# PLANNING AND ZONING CASE CHECKLIST

P&Z CASE # SP2021-026 P&Z DATE 10/12/21 CC DATE \_\_\_\_\_ APPROVED/DENIED \_\_\_\_\_

PROJECT NUMBER: SP2021-026  
PROJECT NAME: Site Plan for Medical Office  
SITE ADDRESS/LOCATIONS: 505 LA JOLLA POINTE DR

**TO:** Planning and Zoning Commission  
**DATE:** October 12, 2021  
**APPLICANT:** Steven Reyes; *Architectonics Texas, LLC*  
**CASE NUMBER:** SP2021-026; *Site Plan for Medical Office*

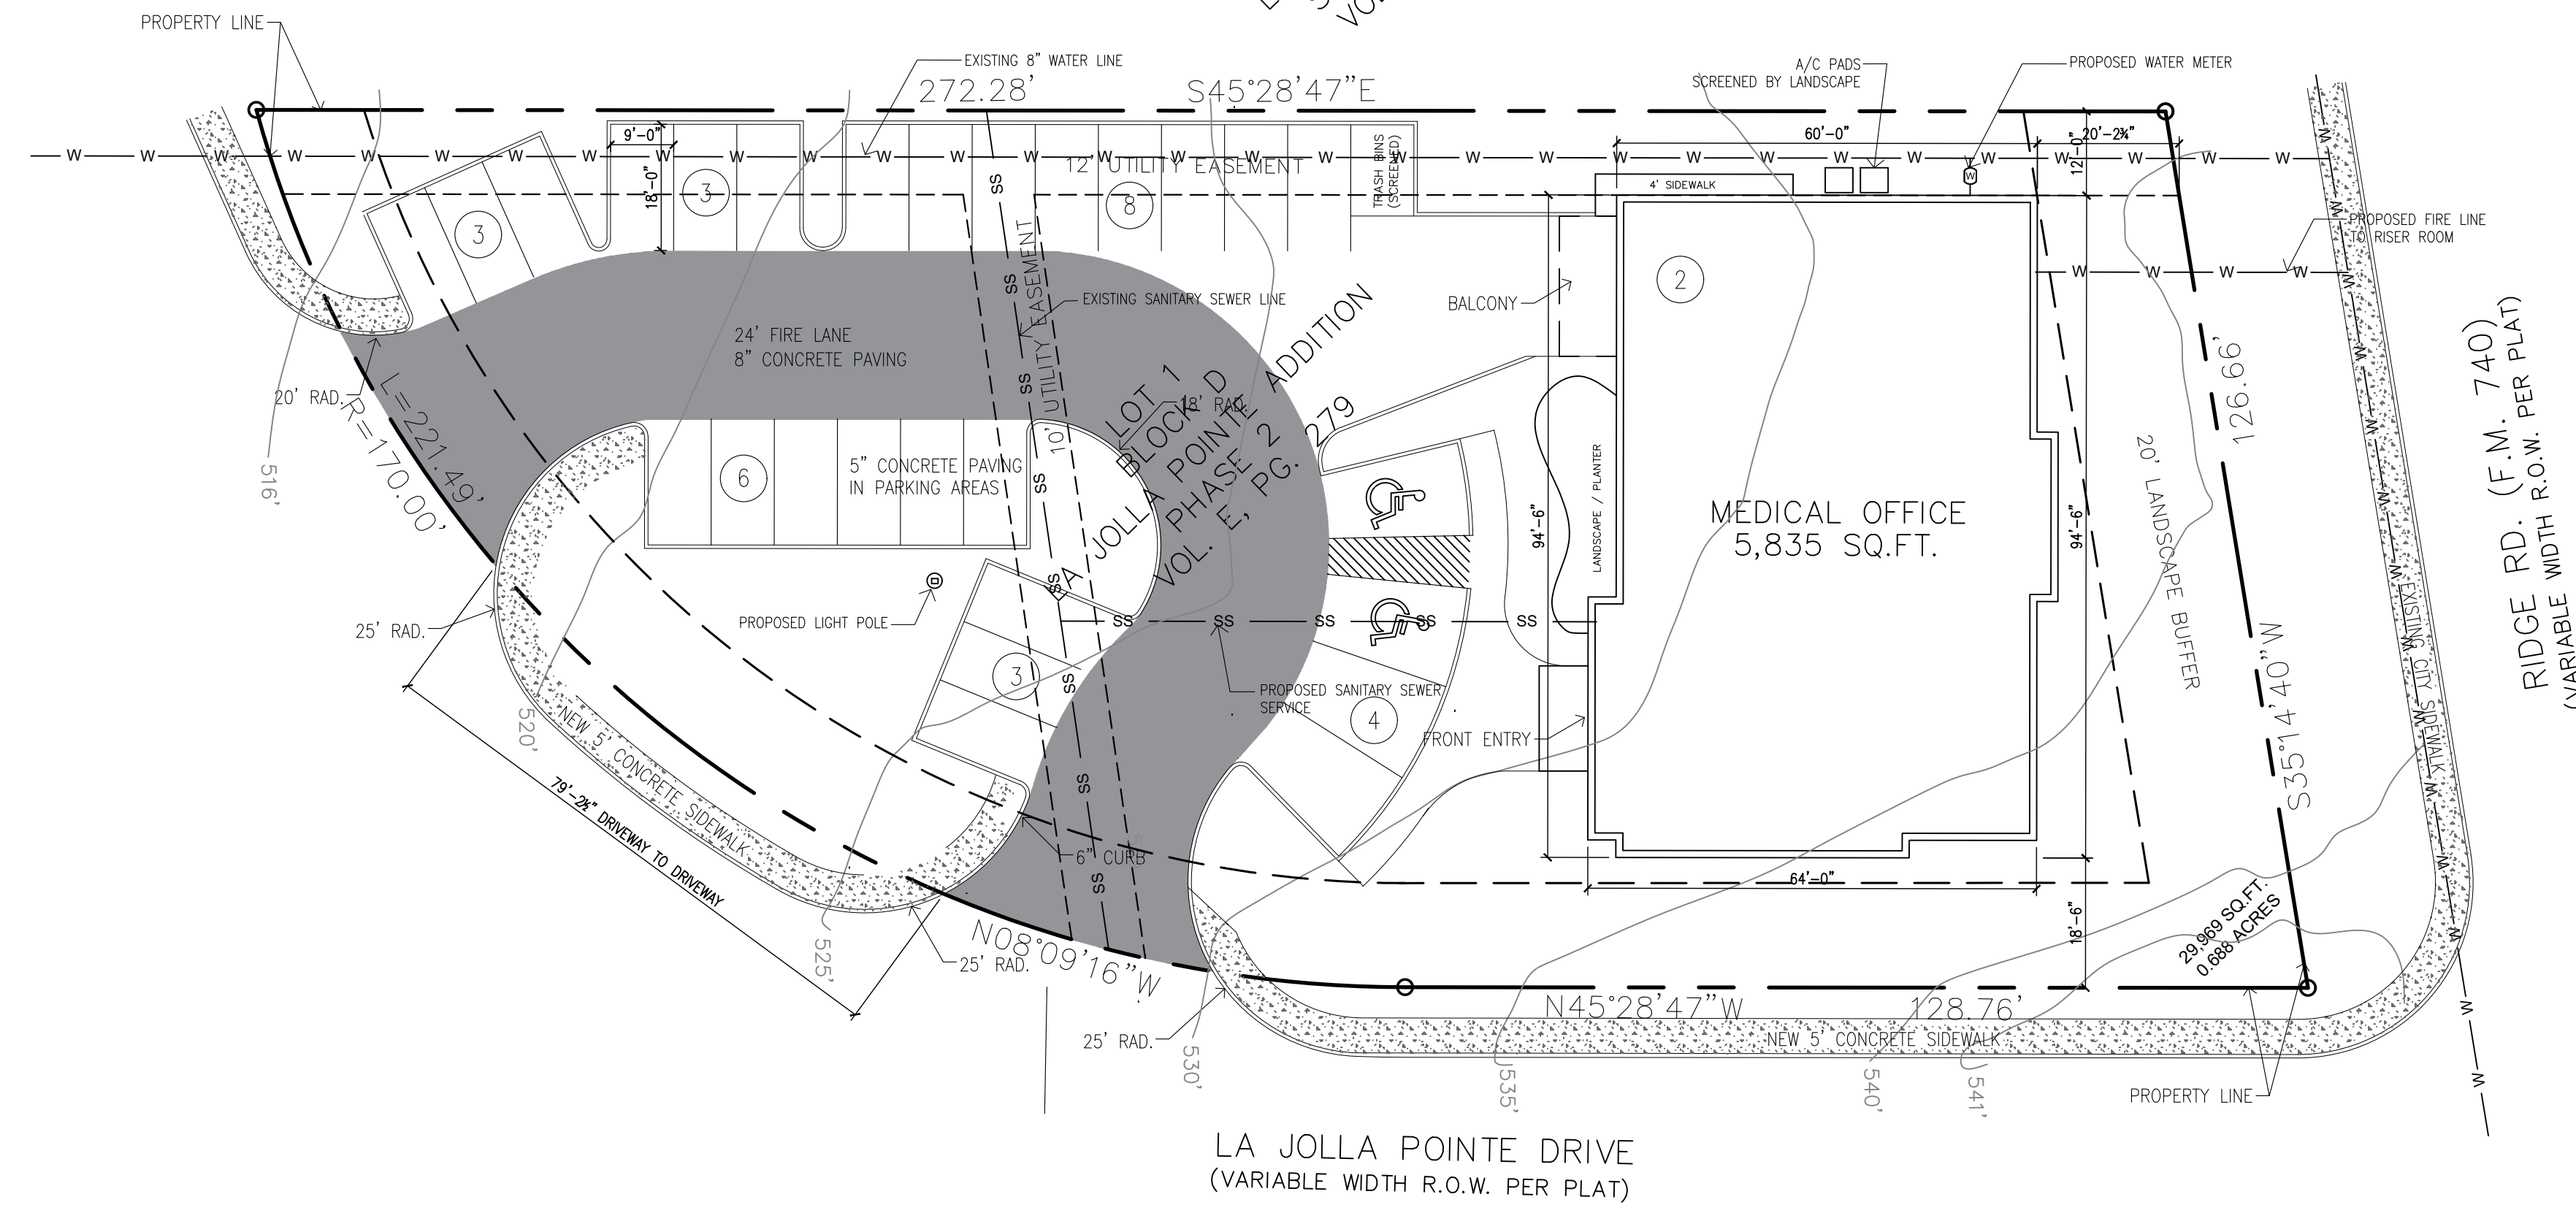
8. Indicate if there are any proposed roof mounted or pad/ground mounted utility equipment and their subsequent screening. (Subsection 01.05.C, of Article 05)
9. Indicate if there is a dumpster on site or if one is to be constructed. If one is to be added to the site it must be indicated; this must include the mandatory screening as well. (Subsection 01.05, B. of Article 05)
10. La Jolla Pointe Drive is identified as a Minor Collector on the Master Thoroughfare Plan contained within the OURHometown Vision 2040 Comprehensive Plan. The minimum spacing requirements for driveways along collector streets are 100-feet. Currently, the site plan shows the driveways are ~79.2083-feet. This will require a variance from the Planning and Zoning Commission (Engineering's Departments Standards of Design and Construction Manual).

09/22/2021: Show location of proposed/existing fire hydrant(s). Hose coverage shall be within 250-ft to all portions of the exterior building walls from a fire hydrant.

Show proposed location for the Fire Department Connection (FDC) for the fire sprinkler system. It shall be within 100-ft of a fire hydrant and facing a fire lane.

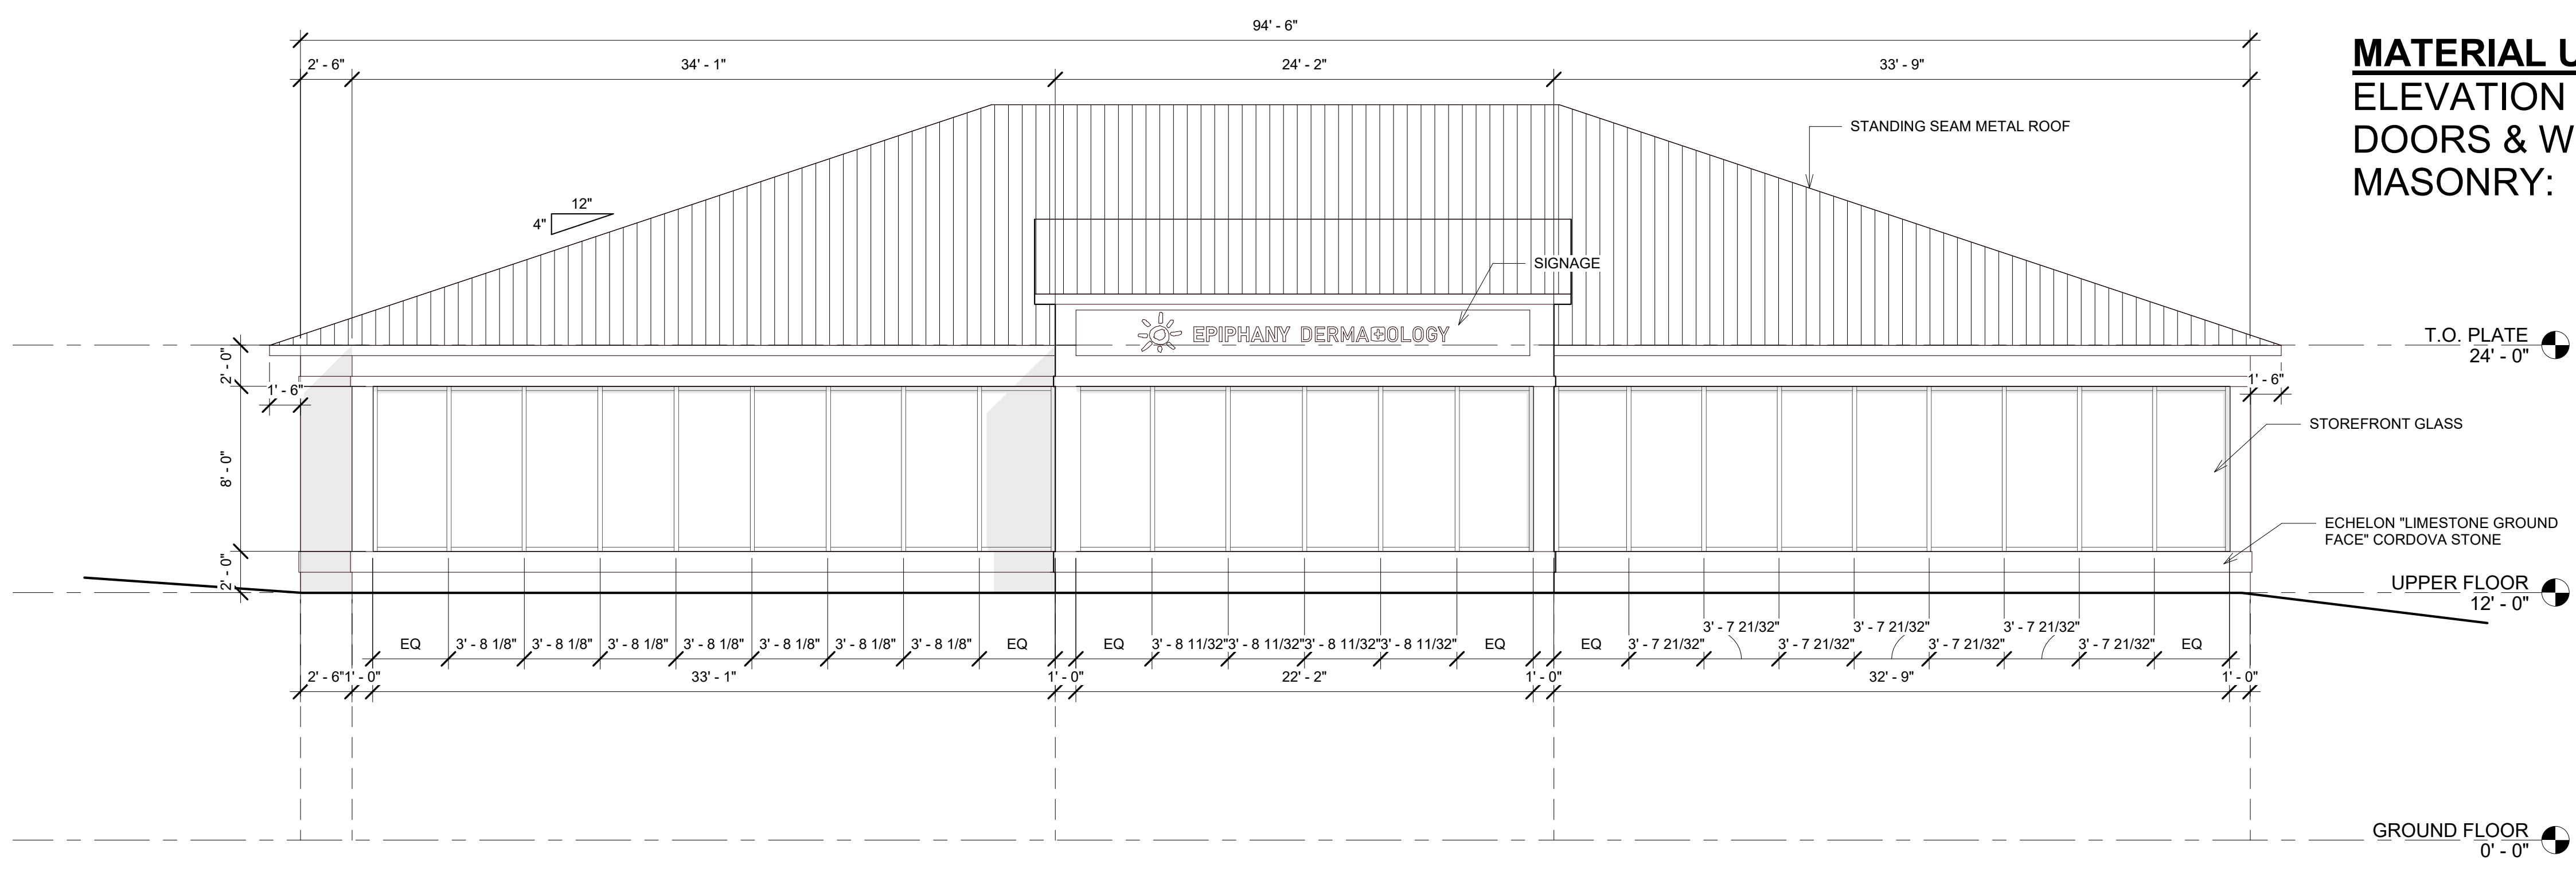
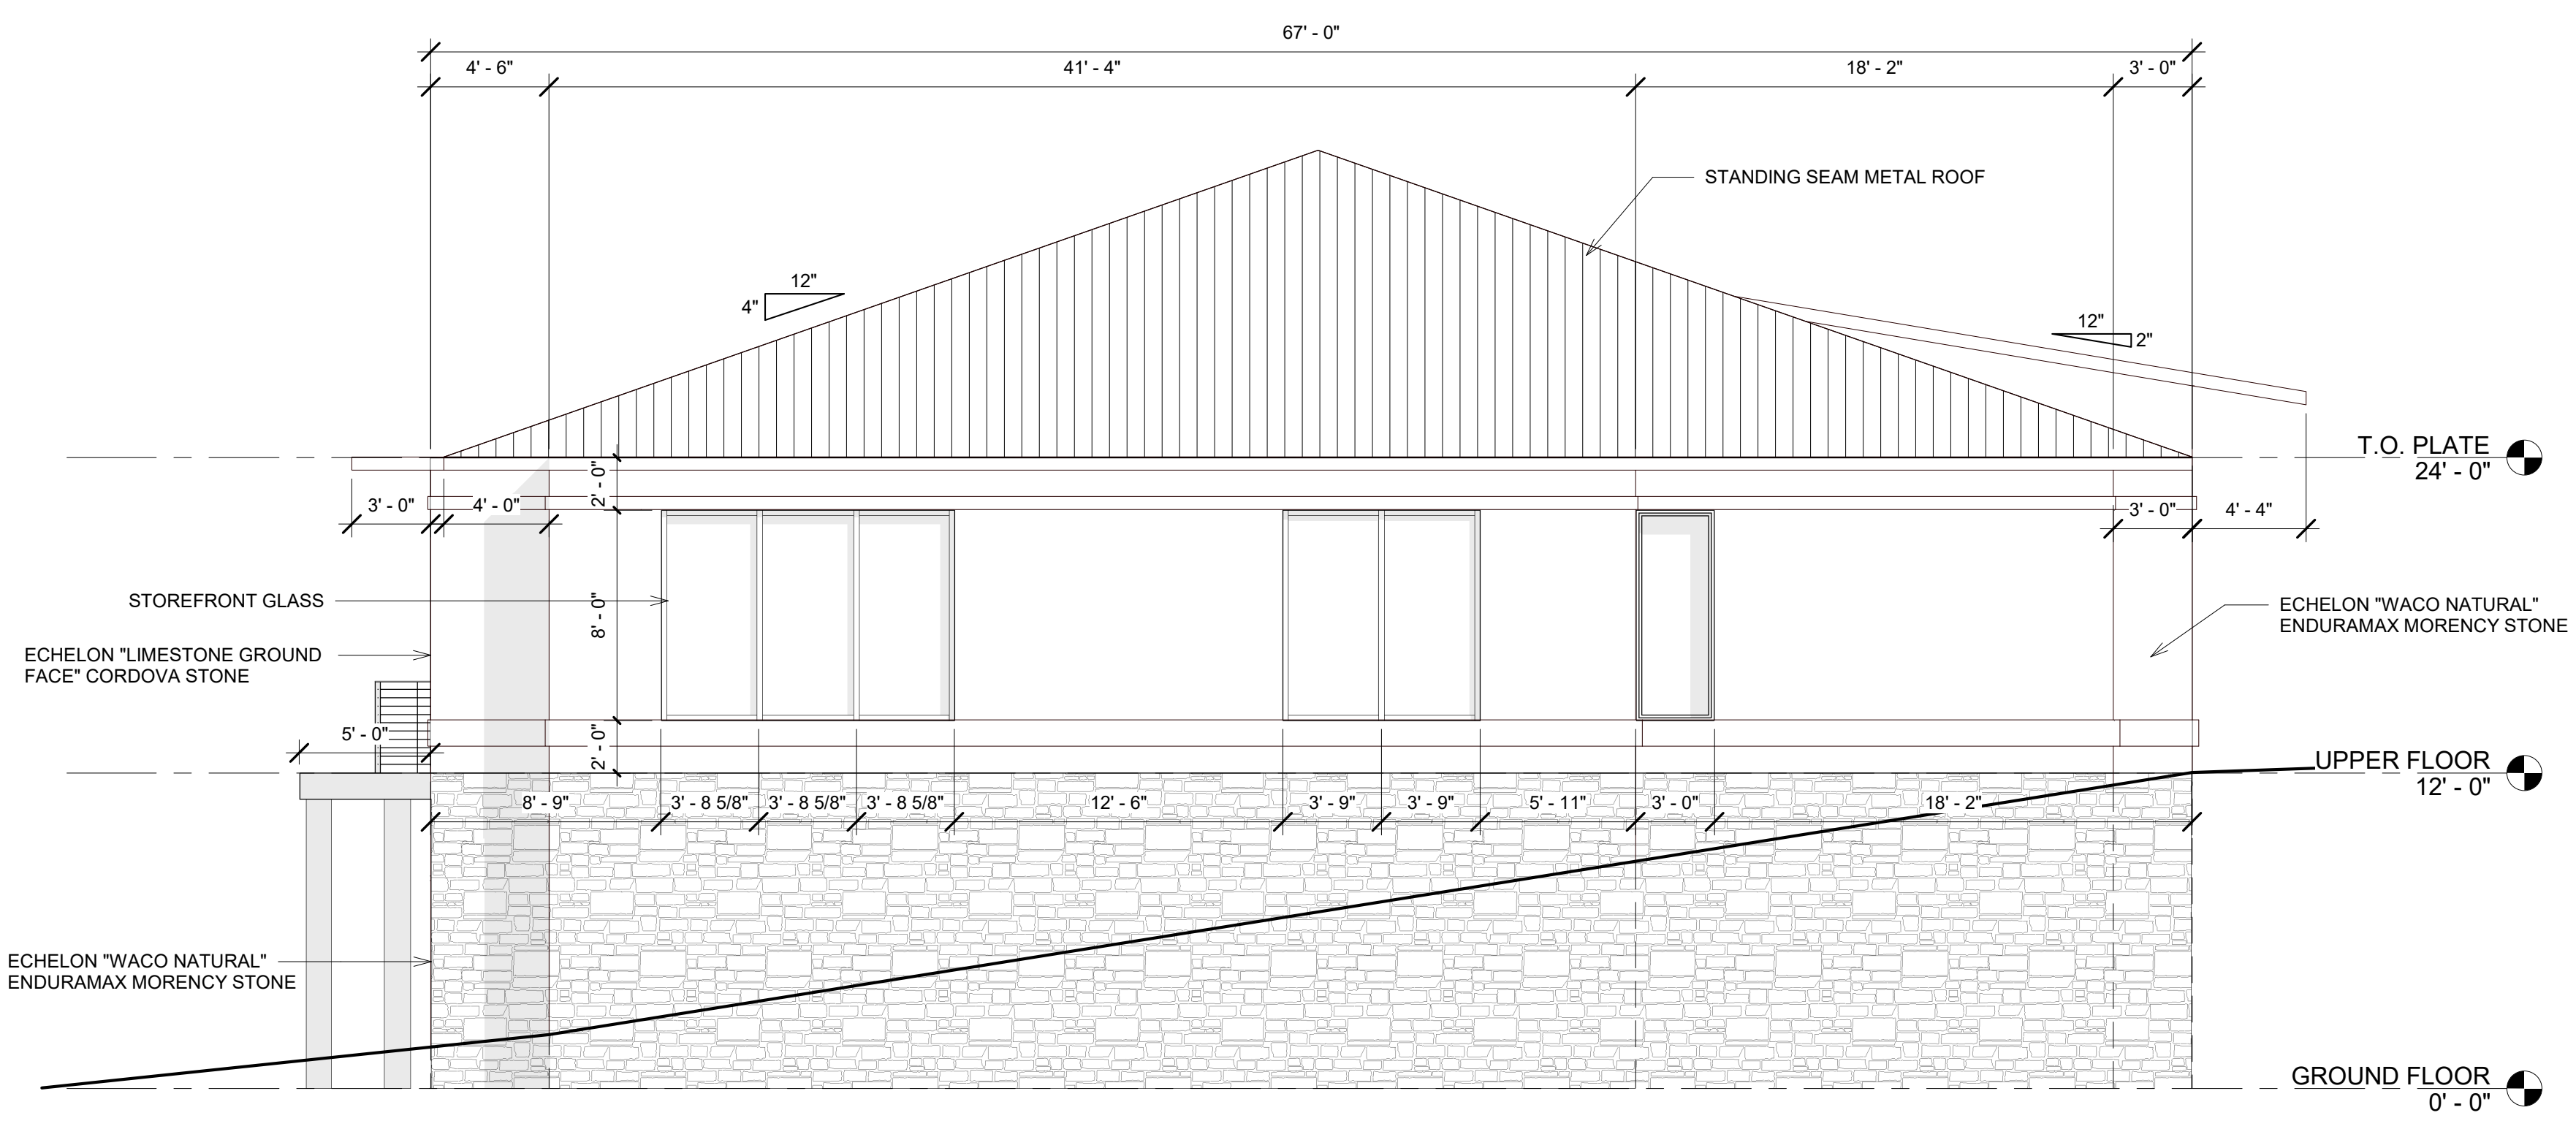
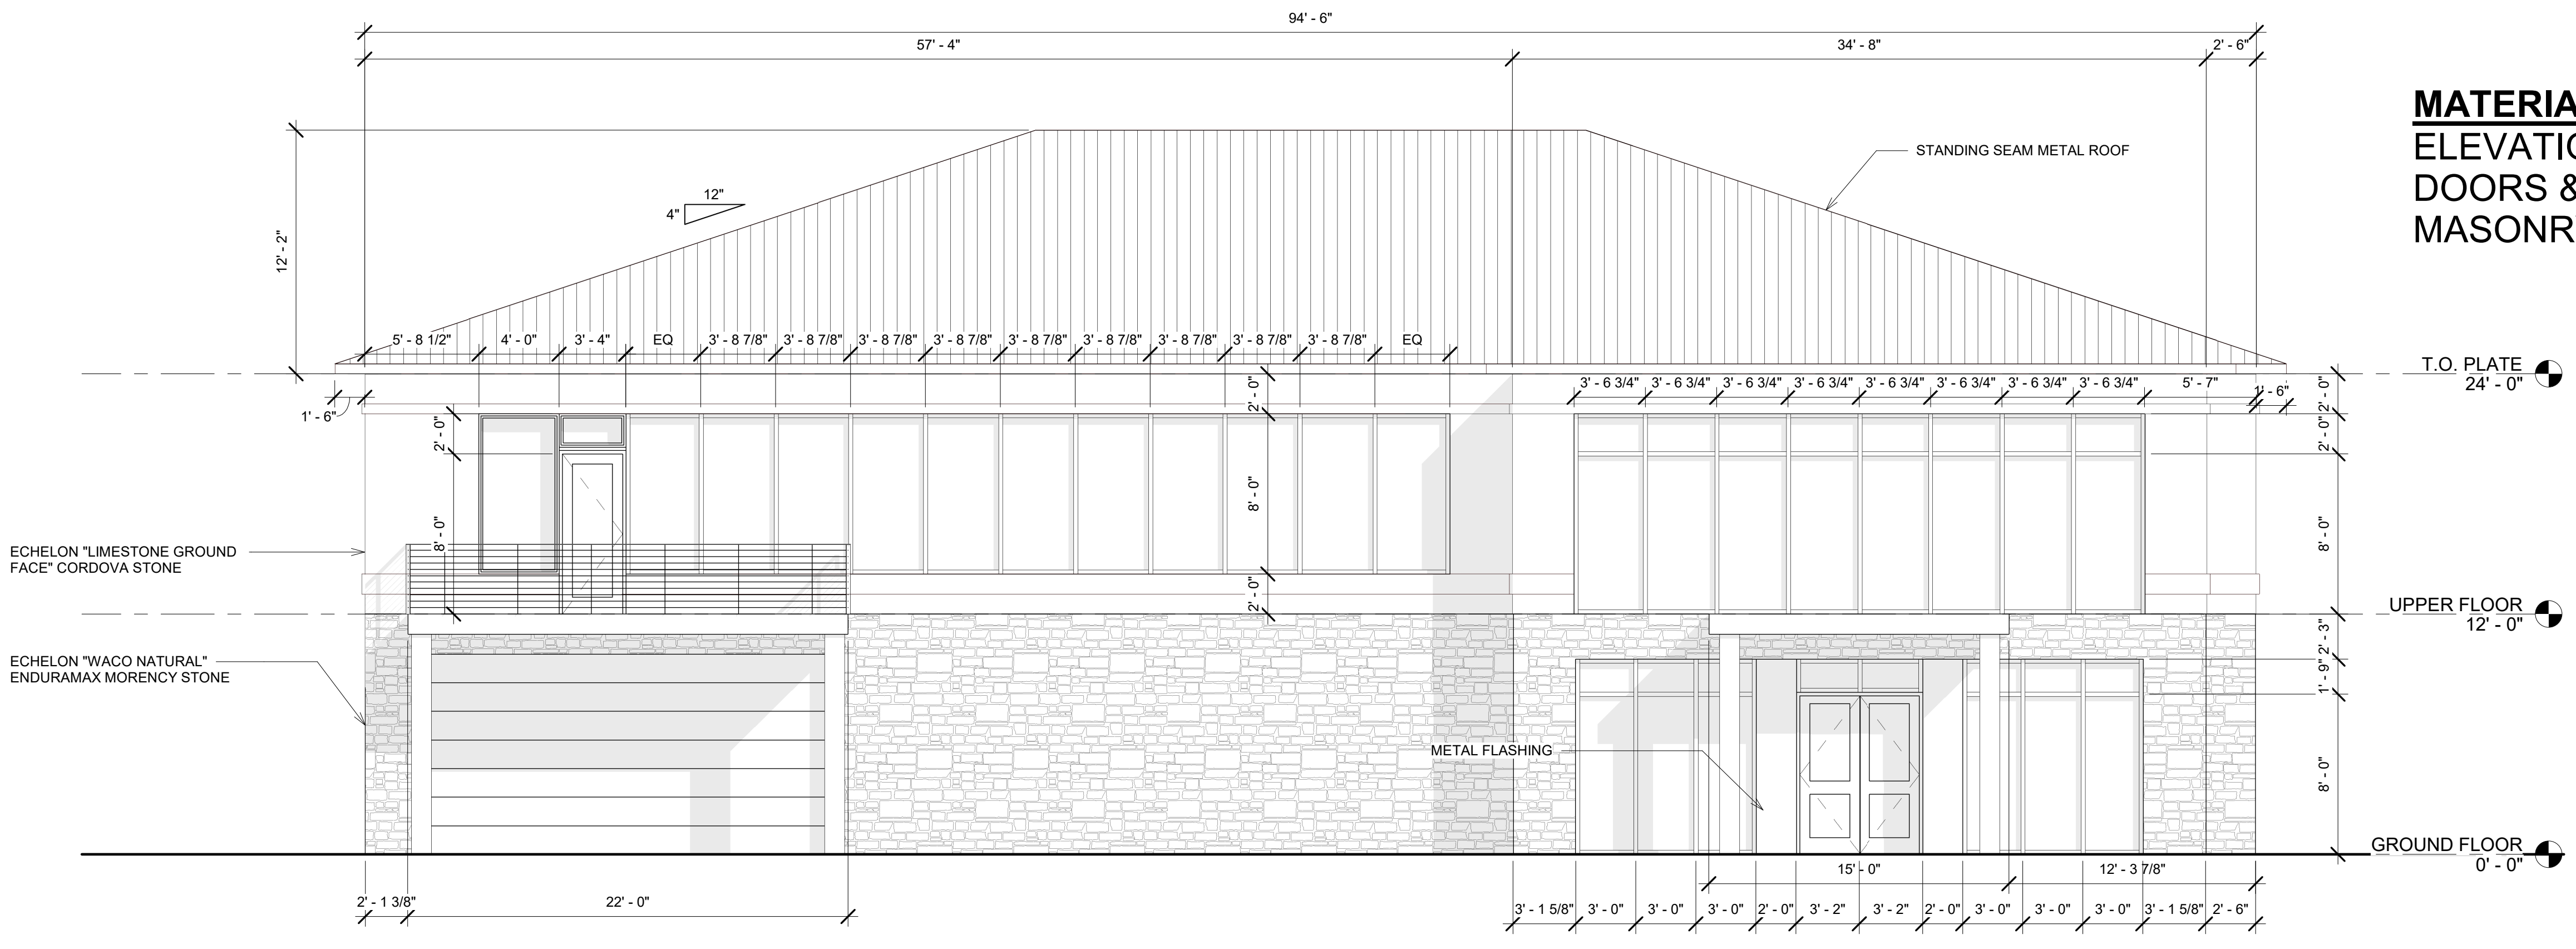
M.6 The standard signature block with signature space for the Planning & Zoning Chairman and Planning Director shall be on each page of the plans. They are currently missing from the elevations. (Subsection 03.04. A, of Article 11)
